**REQUEST**

Current Zoning: R-5 (single family residential) & R-22MF (multi-family residential)  
 Proposed Zoning: UR-2(CD) (urban residential, conditional)

Approximately 1 acre located near the SE intersection of Parkwood Avenue and Hawthorne Lane in the Plaza Midwood community.

**SUMMARY OF PETITION**

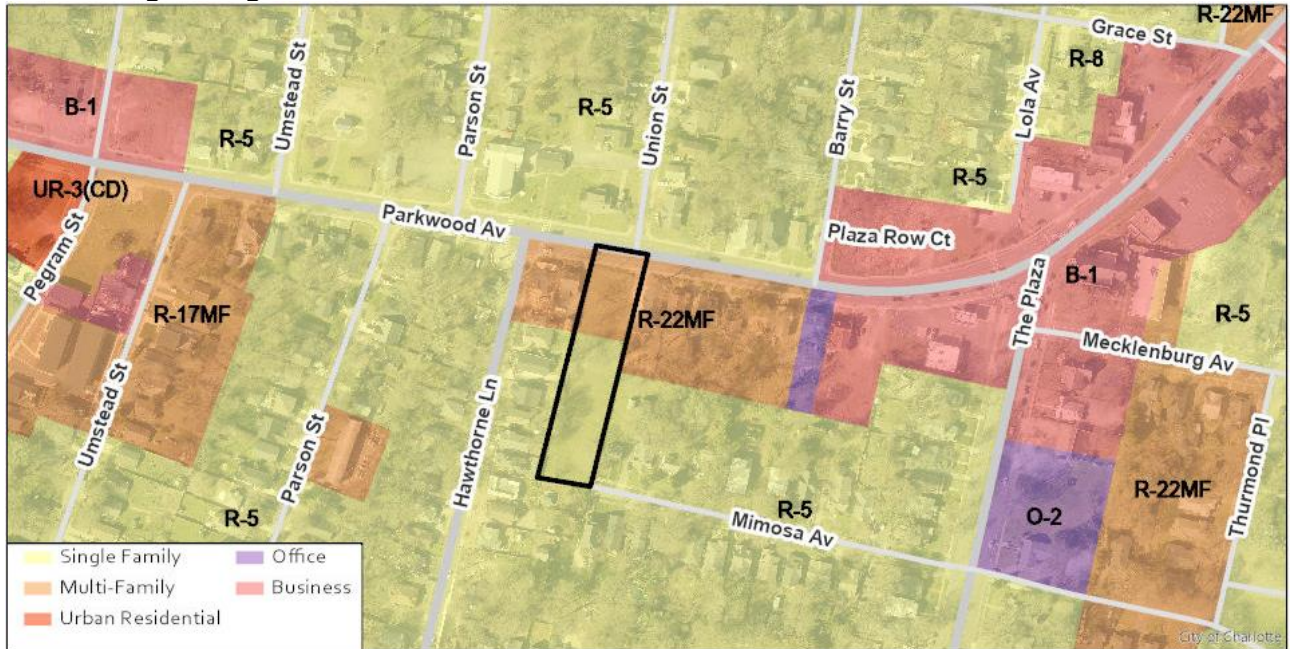
- Proposes 3 single family attached residential units and 22 multi-family residential units (25 total units/ 25 DUA).
  - Within the multi-family structure, two residential units shall be affordable units (80 percent AMI or below) for a period of 15 years.

- Within the single family structure, one residential unit shall be affordable (50 percent AMI or below for a period of 15 years).
- Proposes the construction of two total structures, with the structure closest to Parkwood Avenue being comprised of the 22 proposed multi-family units and the remaining structure constructed near the southern extent of the property.

- Proposes 29 surface parking spaces and three garage parking spaces – provides pervious pavers for a majority of the parking lot.
- Commits to a multi-family building height of 50 40 feet (three stories) and single family attached maximum building height of 35 feet (2.5 stories).

- ~~Provides a driveway connection from Mimosa Avenue for one single family attached triplex building as well as a pedestrian connection from units to the sidewalk along Mimosa Avenue.~~

- ~~Commits to treating the driveway entrance at Mimosa with masonry columns on either side.~~
- Restricts vehicular connections to the site from Mimosa Avenue.

- Provides 6-foot wooden screen fence along the southern and eastern property lines.
- Commits to an improved streetscape along Parkwood Avenue comprised of an 8-foot planting strip and an 8-foot sidewalk.

- Commits to installing an ADA-compliant bus pad along the property's Parkwood Avenue frontage.
- Commits to additional architectural design standards including a commitment to specific building materials, a limitation on the usage of vinyl, the presentation of front or side to all streets, screened HVAC.

- Commits to 15' height for all detached lighting (full cutoff, downwardly directed).
